Access Compliance Report

Public Rights-of-Way

Intersection ID: 13305	Main Street: W_BLAND_ST	Cross Street: WINNIFRED_ST	Location:	N
ADA ID: D1D27B8A4B0A	Ramp Type: PerpDiag	Initial Pass/Fail: Fail	Overall Compliance: No	Severity Score: 21.25

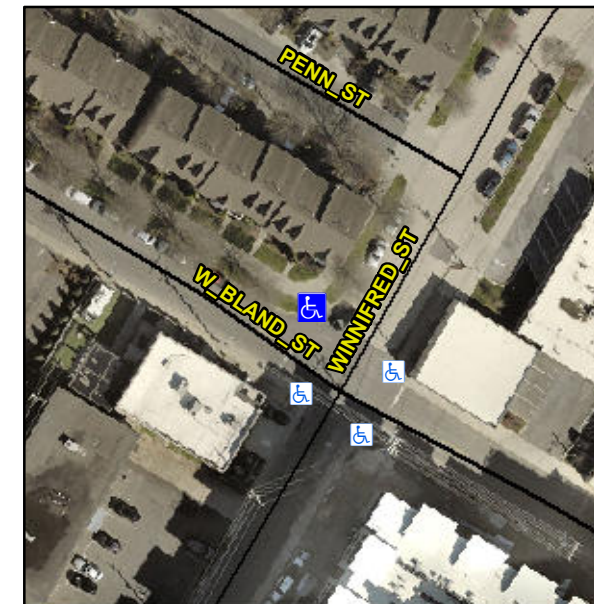
Not Found, R304.5.1, R304.2.2

Compliance	Description	Data	Compliance	Description	Data
N/A	Ramp Length (in)	95.0	No	Ramp Slope (%)	8.5
No	Ramp Width (in)	47.0	Yes	Ramp XSlope (%)	1.0
N/A	Flare Type LT	N/A	N/A	Flare Type RT	N/A
N/A	Flare Slope LT (%)	N/A	N/A	Flare Slope RT (%)	N/A
N/A	Flare Traversable LT?	N/A	N/A	Flare Traversable RT?	N/A
N/A	Landing Length (in)	N/A	N/A	DWS Provided?	N/A
N/A	Landing Width (in)	N/A	N/A	DWS Contrast?	N/A
N/A	Landing Slope (%)	N/A	N/A	DWS Length (in)	N/A
N/A	Landing X Slope (%)	N/A	N/A	DWS Full Width?	N/A
N/A	Landing Curb? (Y/N)	N/A	N/A	DWS Offset (in)	N/A
N/A	Shared Landing?	N/A			
N/A	Gutter Ponding?	N/A	N/A	Gutter Slope (%)	N/A
N/A	Gutter Lip Ht (in)	N/A	N/A	Gutter X Slope (%)	N/A
N/A	Painted X Walk1?	No	N/A	Painted X Walk2?	No
	X Walk 1 Direction	To SW		X Walk 2 Direction	To SE
N/A	X Walk 1 Width (in)	N/A	N/A	X Walk 2 Width (in)	N/A
	X Walk 1 Slope (%)	2.1		X Walk 2 Slope (%)	5.3
	X Walk 1 X Slope (%)	1.2		X Walk 2 X Slope (%)	1.7

Remove & Replace Curb Ramp With Two New Directional Ramps or Equivalent.
